MITSUBISHI HEAVY INDUSTRIES, LTD.
16-5, KONAN 2-CHOME, MINATO-KU
TOKYO, JAPAN

Subject: MHI's Responses to US-APWR DCD RAI No. 571-4365

Responses to Request for Additional Information
No. 571-4365 Revision 0
(Follow up to No. 362-2278 Revision 0)

RAI NO.: NO. 571-4365 REVISION 0
SRP SECTION: 09.02.02 – REACTOR AUXILIARY COOLING WATER SYSTEM
APPLICATION SECTION: 9.2.2
DATE OF RAI ISSUE: 4/13/2010

Figure 2.7.3.3-1 Component Cooling Water System (Sheet 2 of 2)

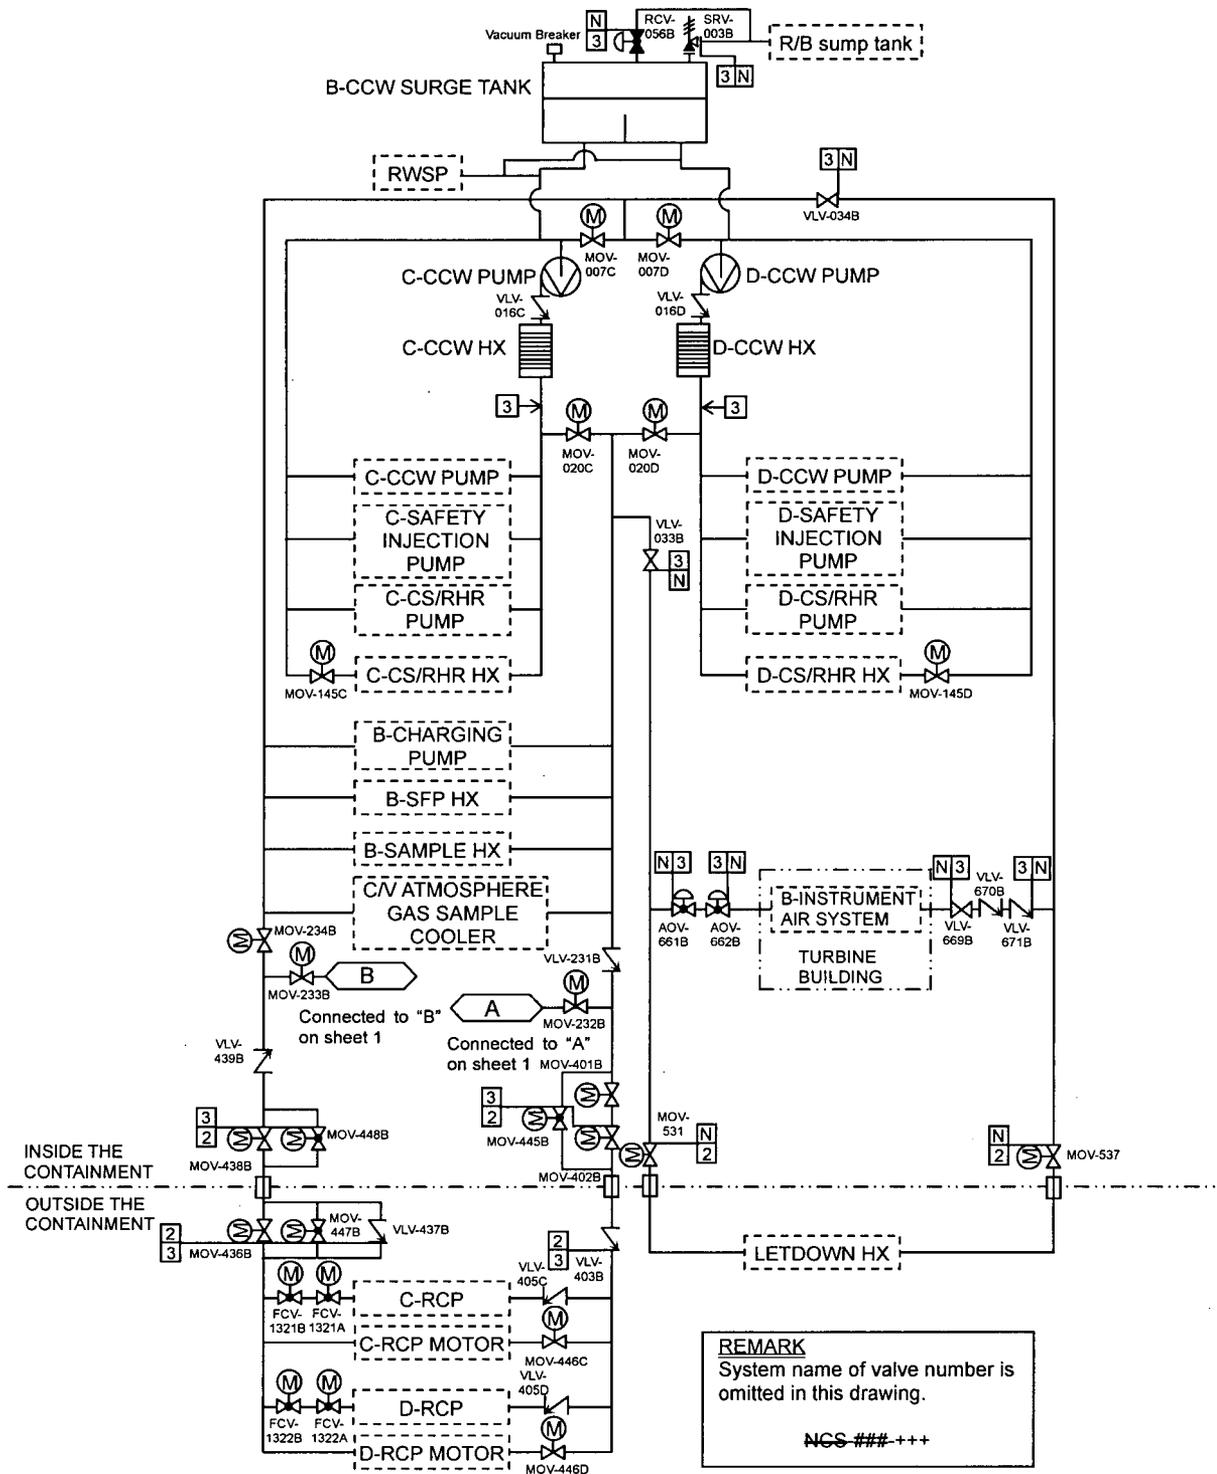
Items 8 and Item 10: The staff was unable to accept the response since it was unclear as to whether the surge tank is sized for system leakage for 7 days without makeup or if credit is taken for a seismic source for 7 days. The tank size and seismic makeup should be address in Tier 1.

Item 15: The staff was unable to accept the response since the Tier 1 figures and Tier 2 figures disagree. Specifically, the placement of the thermal barrier cross-tie header is upstream of the charging pump as shown on the Tier 2 figures and the placement of MOV-234A/B are incorrect on the Tier 1 figures. Check valves VLV-231A and VLV-231B are important design features as part of the thermal barrier cross-tie and should be shown in the Tier 1 figures.

DCD Tier 1 figure 2.7.3.3-1 will be revised to show the surge tank water seismic category I makeup Line.

Item 8 and 10: Please see the response to RAI 09.02.02-51 regarding the addition of makeup water sources to Tier 1 DCD Figure 2.7.3.3-1 and Question 09.02.02-57 regarding the addition of Surge Tank volume to Tier 1 DCD Table 2.7.3.3-5.

Item 15: Tier 1 DCD Figure 2.7.3.3-1 will be revised per the attached to show check valves VLV-231A and VLV-231B. The placement of the thermal barrier cross-tie header on the Tier 1 figure has not been changed. As a functional flow diagram the Tier 1 figure is not intended to show the relative position of branches in a continuous pipe line since there is no functional difference. Likewise a future change in the relative position with no functional change should not require a Tier 1 revision.
